Final Drainage Report
for
WindingWalk Filing 2
at
Meridian Ranch

EL PASO COUNTY, COLORADO

July 2018

SF-18-022

Scale	AS SHOWN	4 of 4	
	Drawn by	Checked by	Date
TECH CONTRACTORS 12311 REX ROAD FALCON, CO 80831 TELEPHONE: 719.495.7444 FAX: 719.495.2457		Revisions	No.
MERIDIAN RANCH		RATIONAL DRAINAGE MAP FINAL DRAINAGE REPORT WINDINGWALK FLING 2	
FIGURE 7		JUL 2008

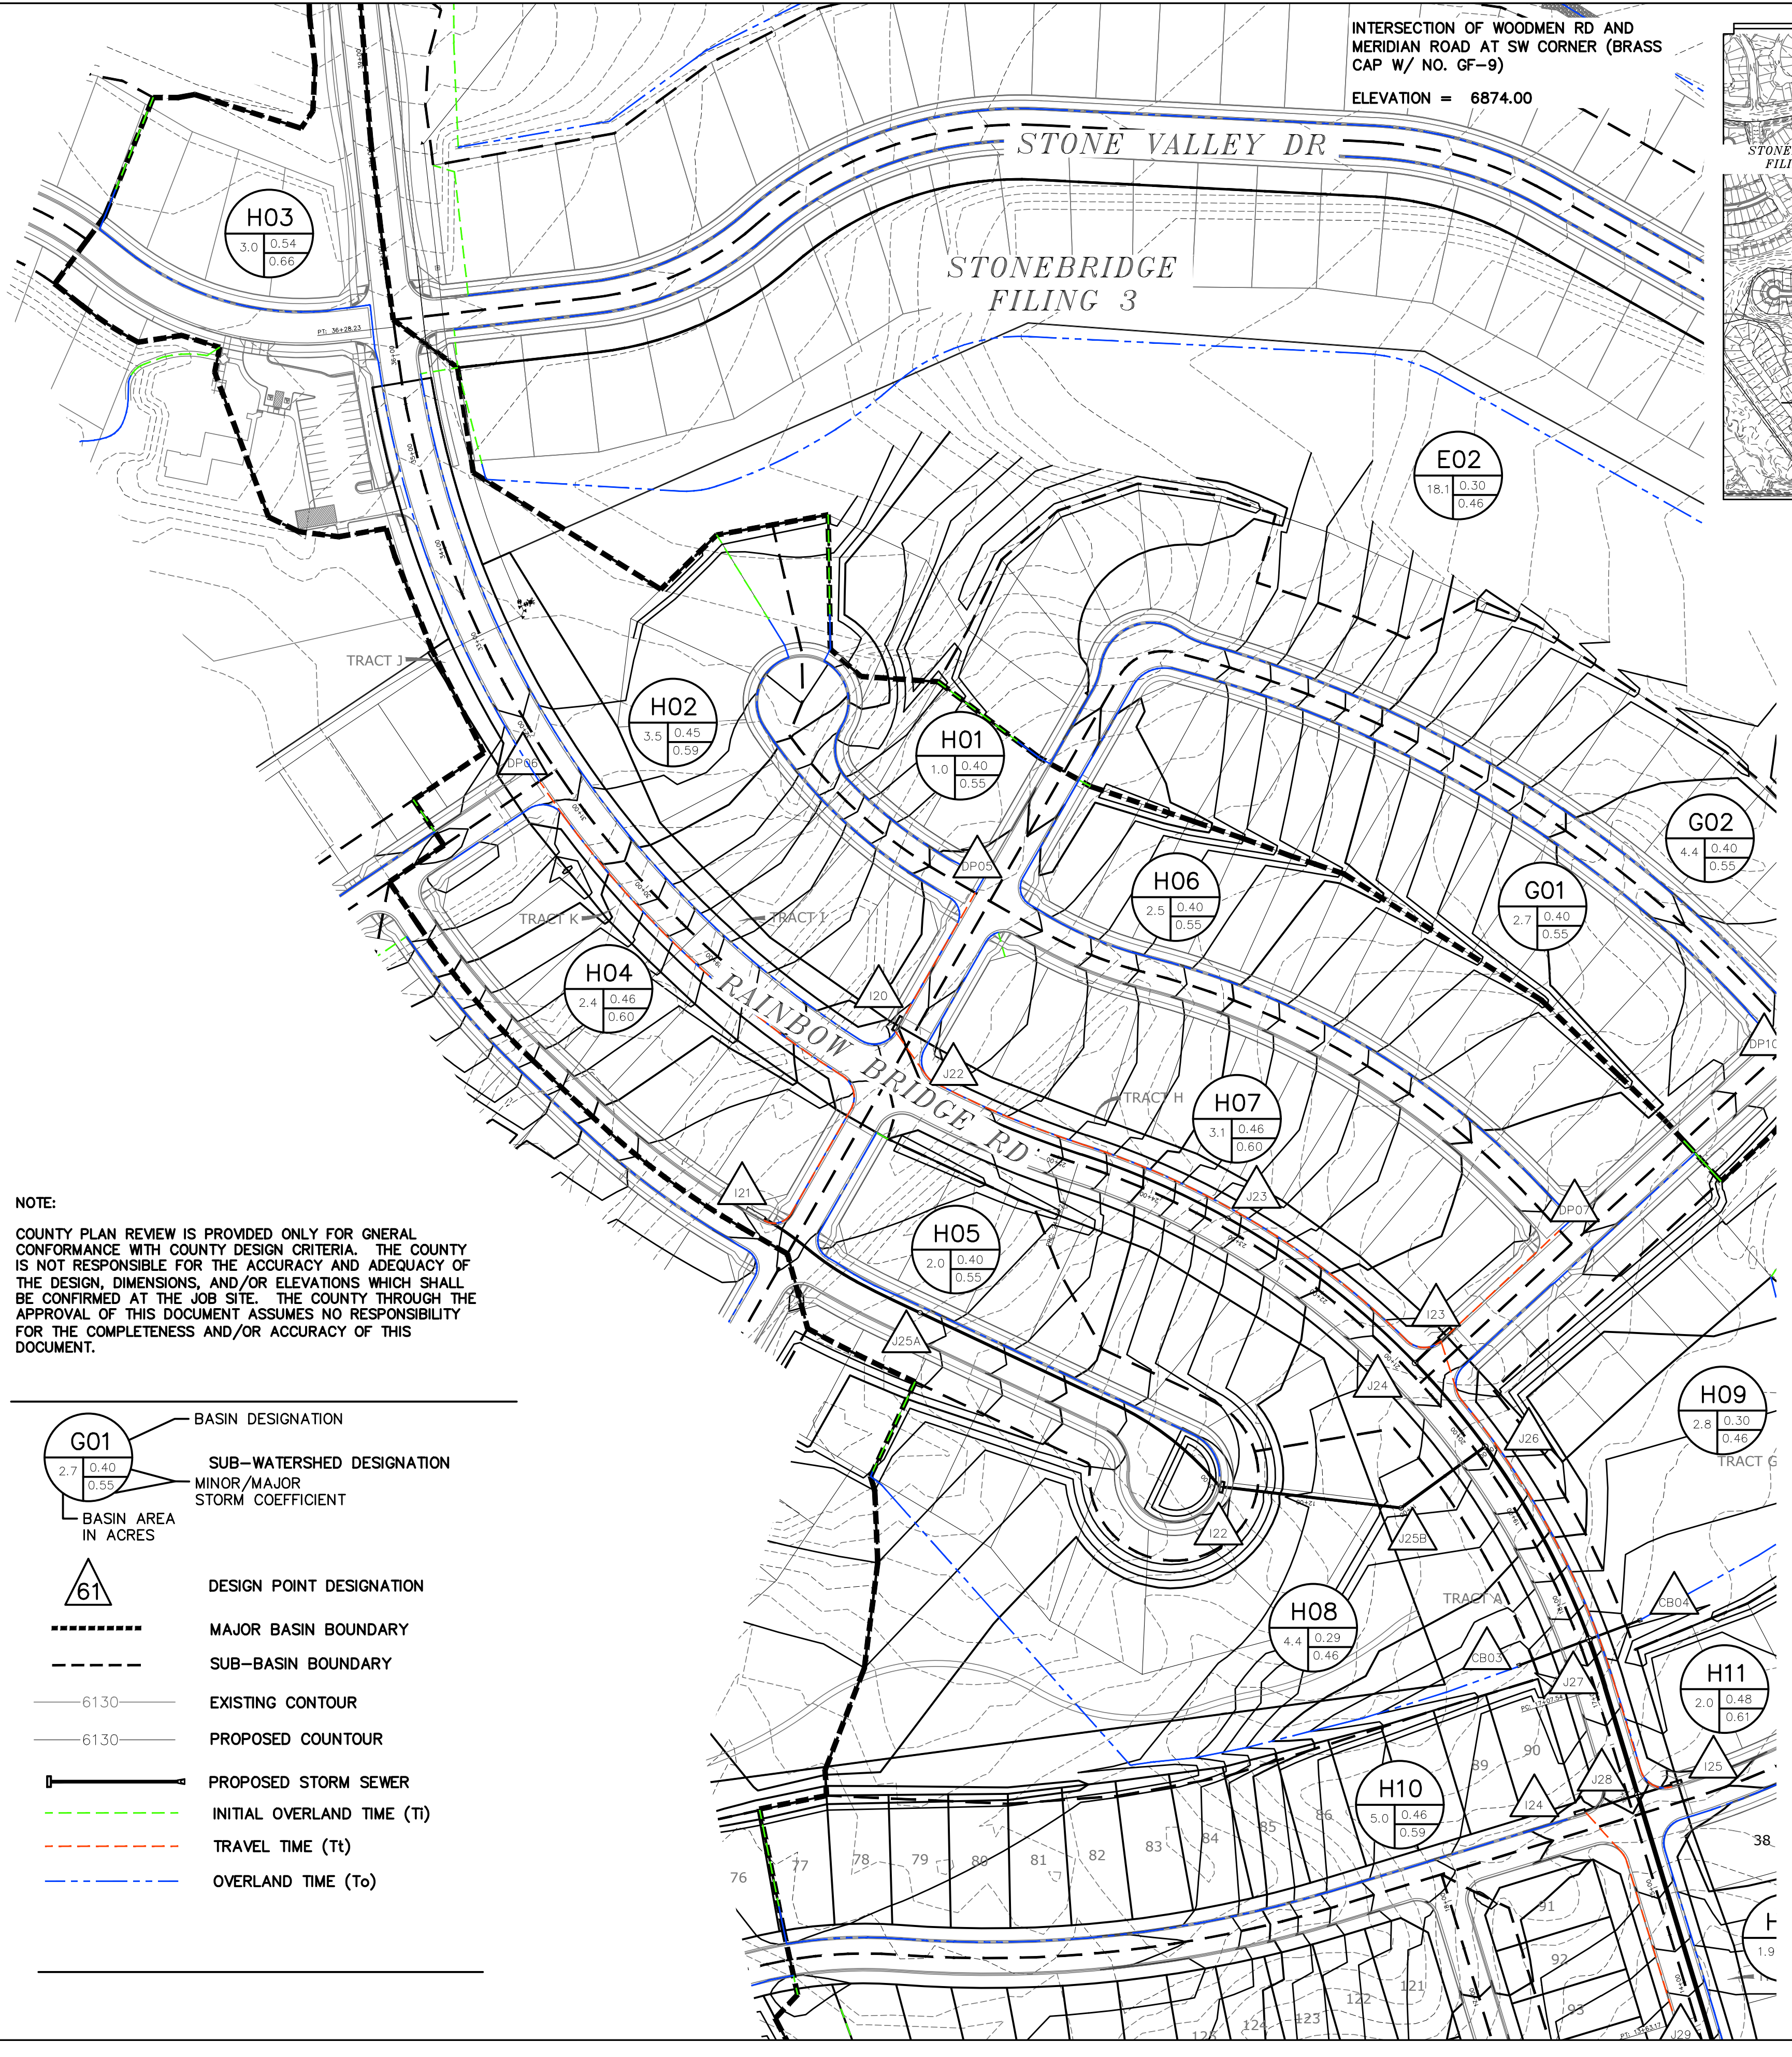
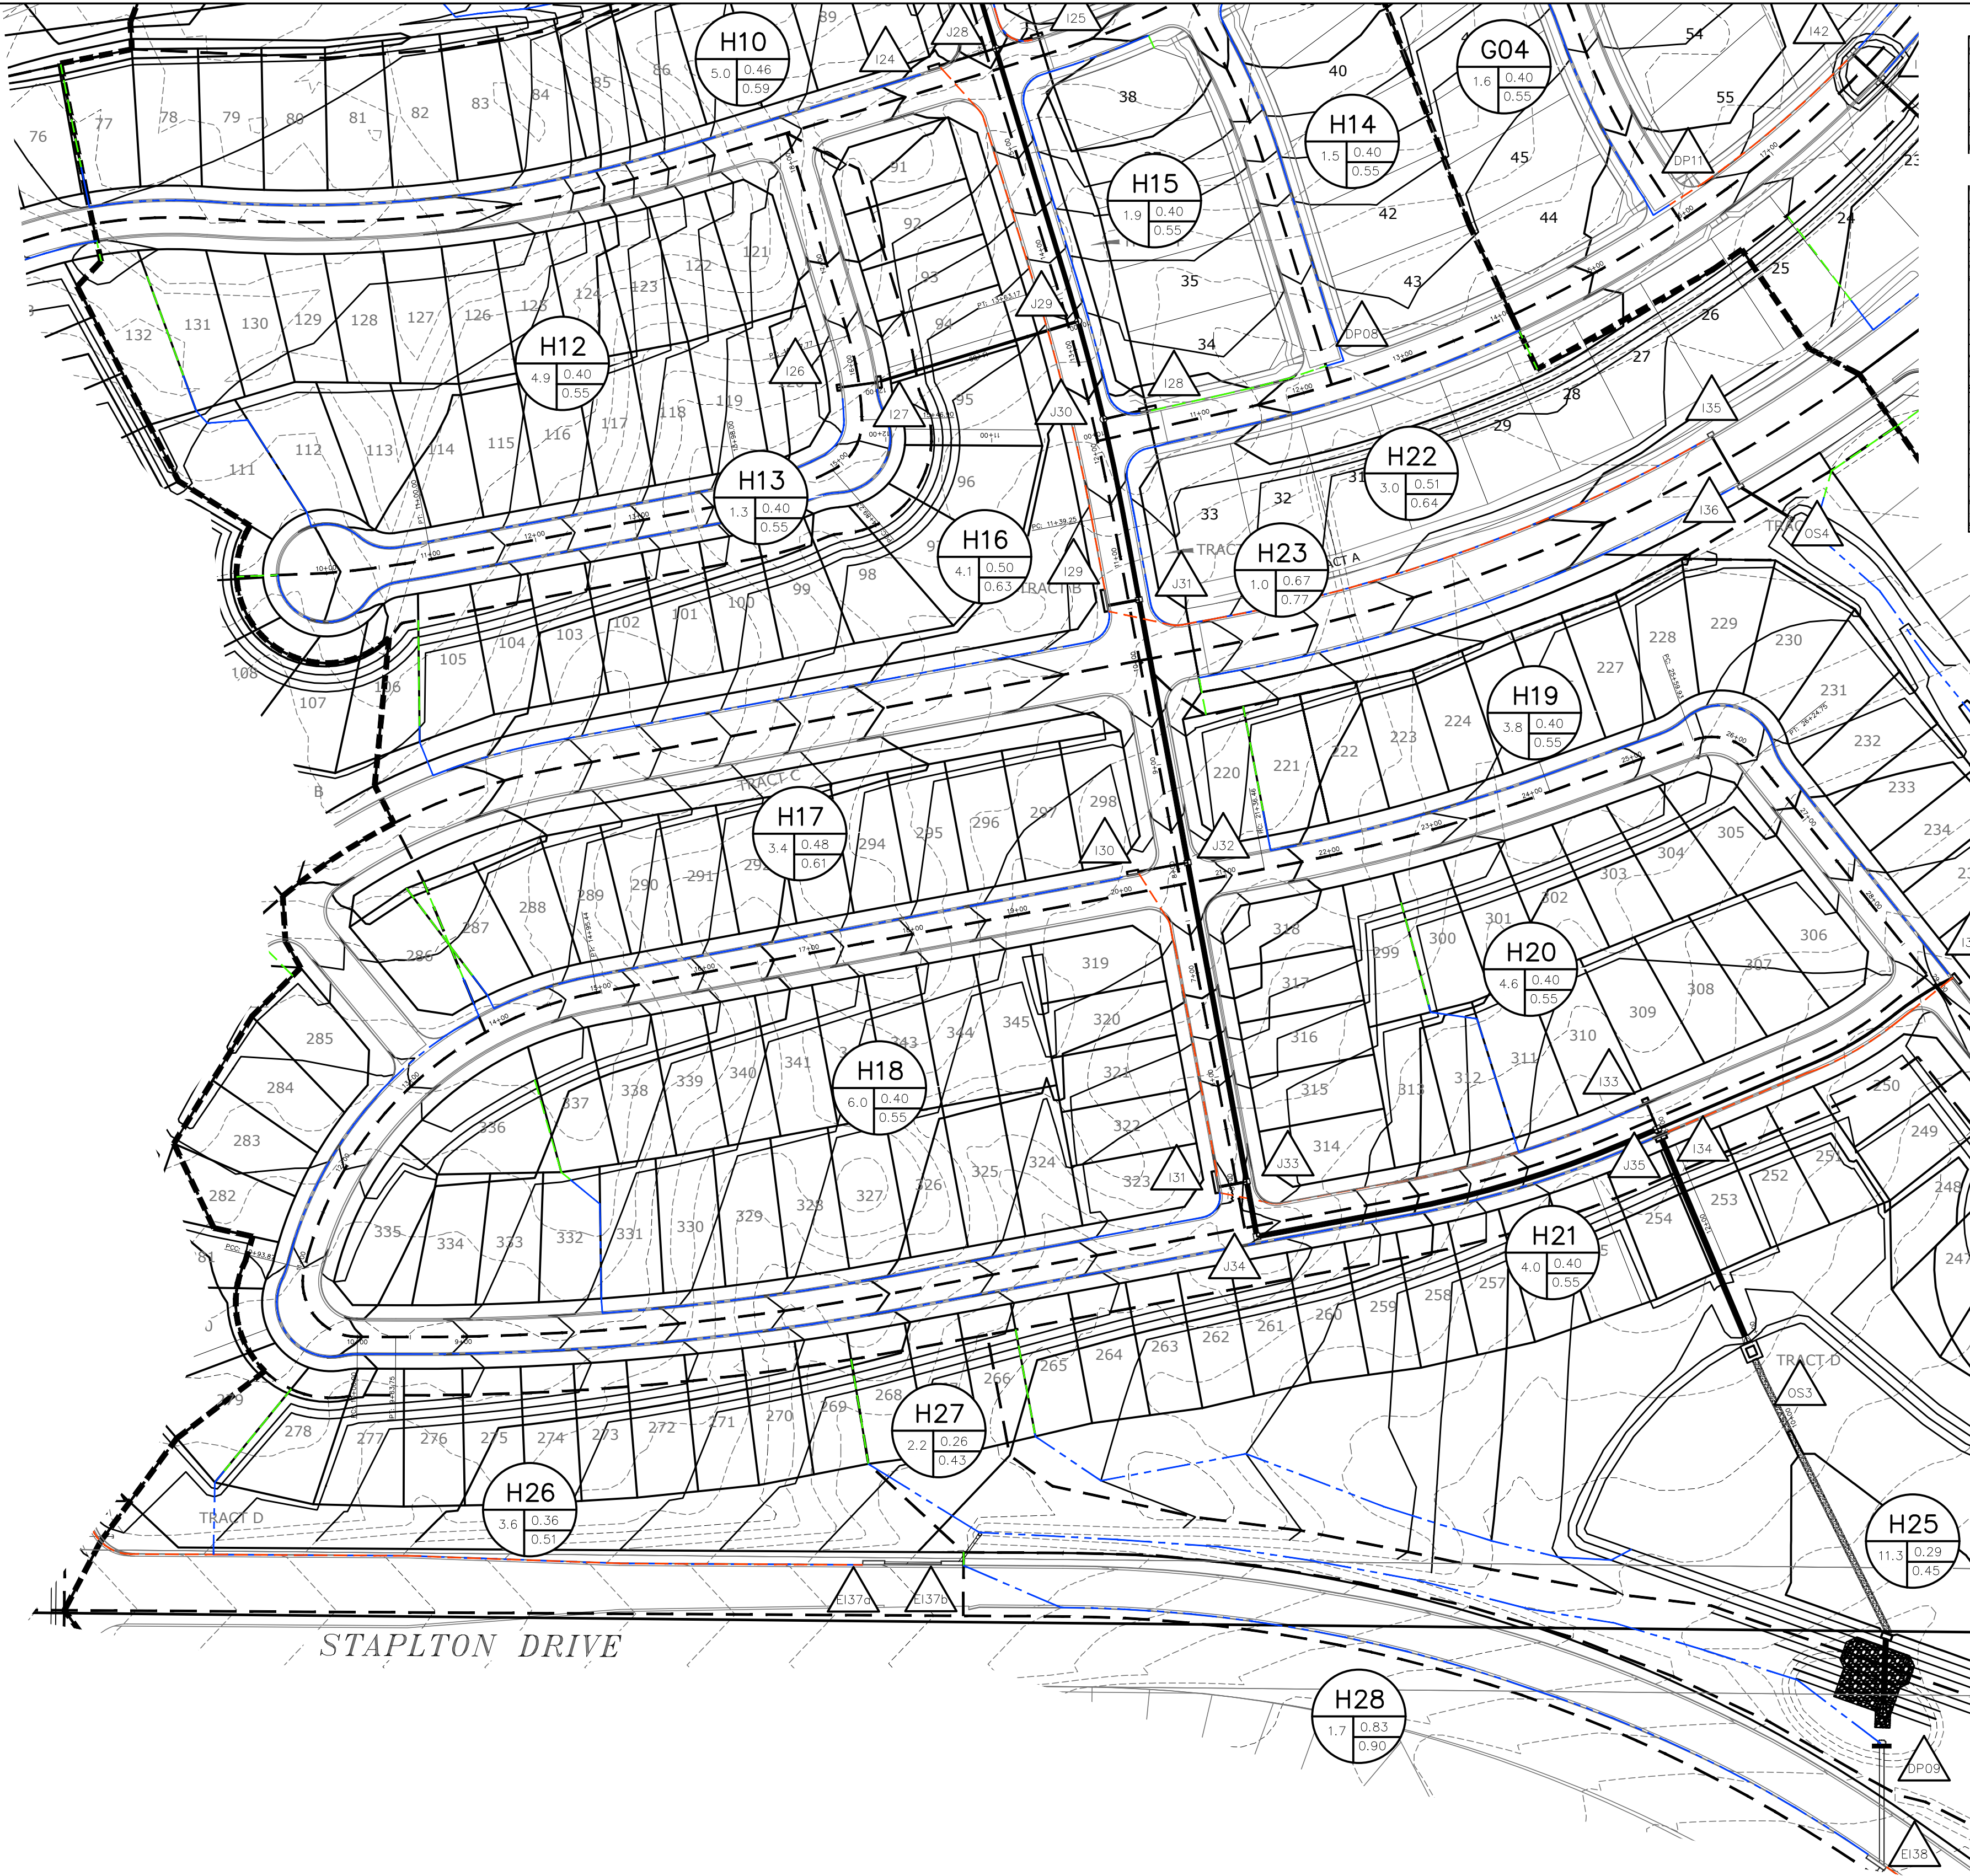
Update the rational drainage map and calculations to specifically be for winding walk filing 2. You can add text box identifying the surrounding subdivision filing or highlight the subject area. The majority of the subbasins in sheets 1 & 3 are for a different subbasin.
Main takeaway is that the project area should be readily discernible.
